## Errata Sheet V1.0

- The following datasheets:
  - AT91M63200 Summary, Rev. 1028DS–05/00
  - AT91M63200, Rev. 1028A–10/99
  - AT91M43300 Summary, Rev. 1322A–10/99
  - AT91M43300, AT91M63200 Electrical Characteristics, Rev. 1090B–05/00
- 176-lead TQFP and 144-ball BGA devices with the following markings:

**AT91  
ARM<sup>®</sup> Thumb<sup>®</sup>  
Microcontrollers**

**AT91M63200  
AT91M43300  
Errata Sheet  
V1.0**

**Figure 1. NWAIT Rising**

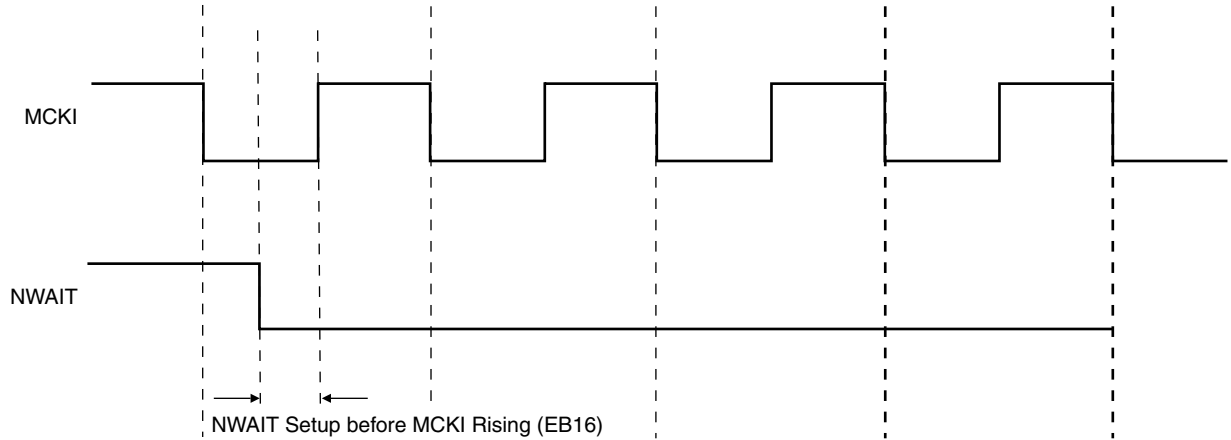
If the NWAIT setup time is satisfied on the first rising edge of MCKI, the behavior is accurate. The EBI operations are not affected when the NWAIT rises.

**Figure 2. Number of Standard Wait States is Two**

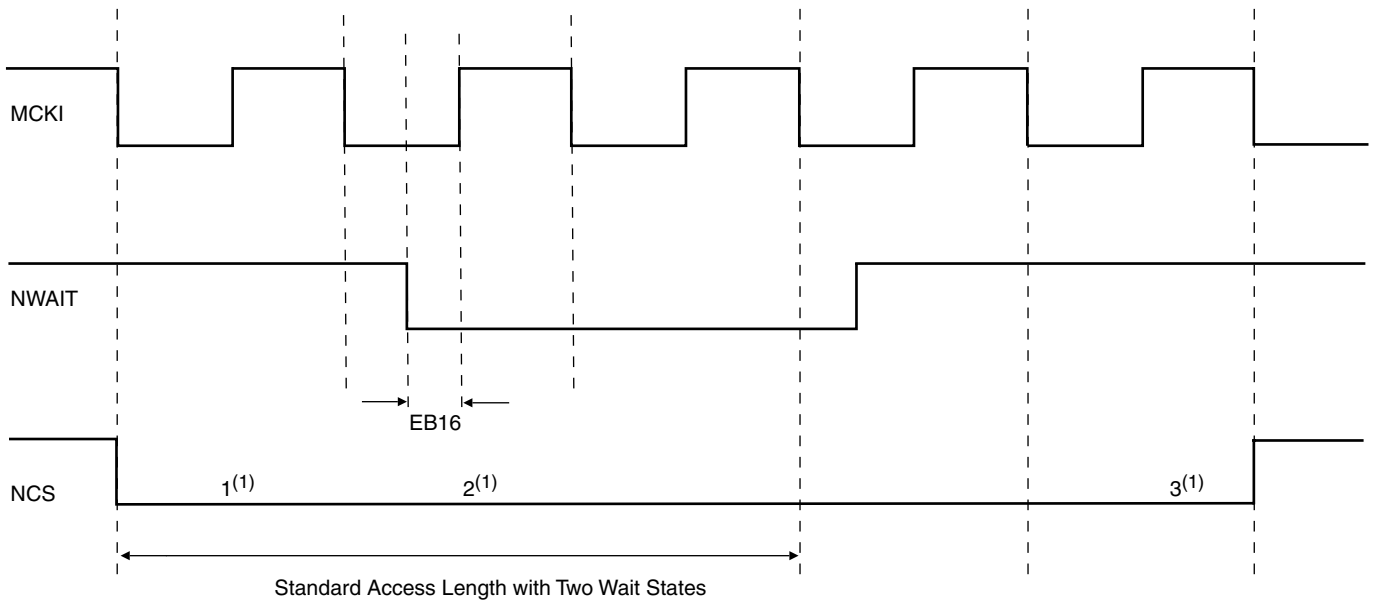
If the NWAIT setup time is satisfied on the following edges of MCKI and if at least one standard wait state remains to be executed, the behavior is accurate. In the following example, the number of standard wait states is two. The NWAIT setup time on the second rising edge of MCKI must be met.

**Figure 3.** Number of Standard Wait States is One

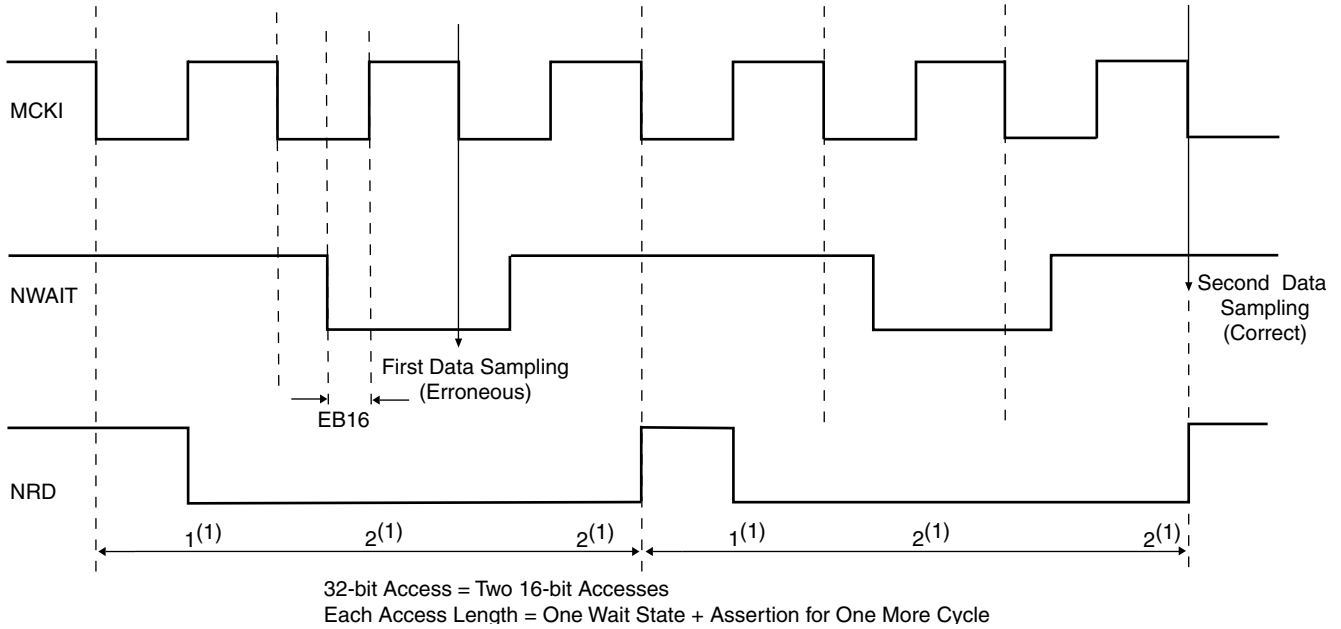
If the first two conditions are not met during a 32-bit read access, the first 16-bit data is read at the end of the standard 16-bit read access. In the following example, the number of standard waits is one. NWAIT assertions do affect both NRD pulse lengths, but first data sampling is not delayed. The second data sampling is correct.

At maximum speed, asserting the NWAIT in the first access cycle is not possible, as the sum of the timings “MCKI Falling to Chip Select” and “NWAIT setup to MCKI rising” are generally higher than one half of a clock period. This leads to using at least one standard wait state. However, this is not sufficient except to perform byte or half-word read accesses. Word and write accesses require at least two standard wait states.

**Figure 4.** Description of the Number of Standard Wait States

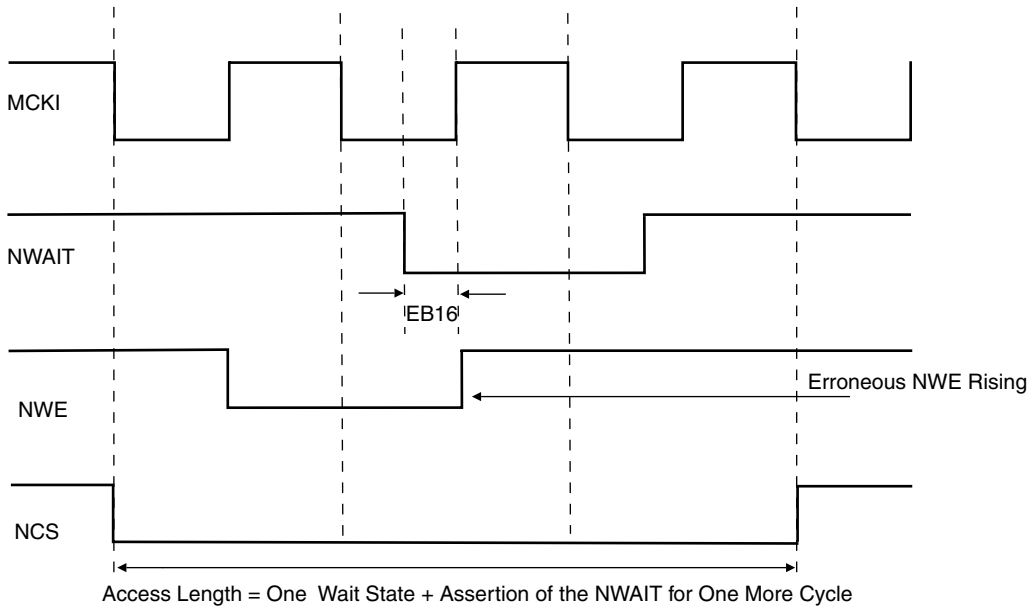
If the first two conditions are not met during write accesses, the NWE signal is not affected by the NWAIT assertion. The following example illustrates the number of standard wait states. NWAIT is not asserted during the first cycle, but is asserted at the second and last cycle of the standard access. The access is correctly delayed as the NCS line rises accordingly to the NWAIT assertion. However, the NWE signal waveform is unchanged, and rises too early.
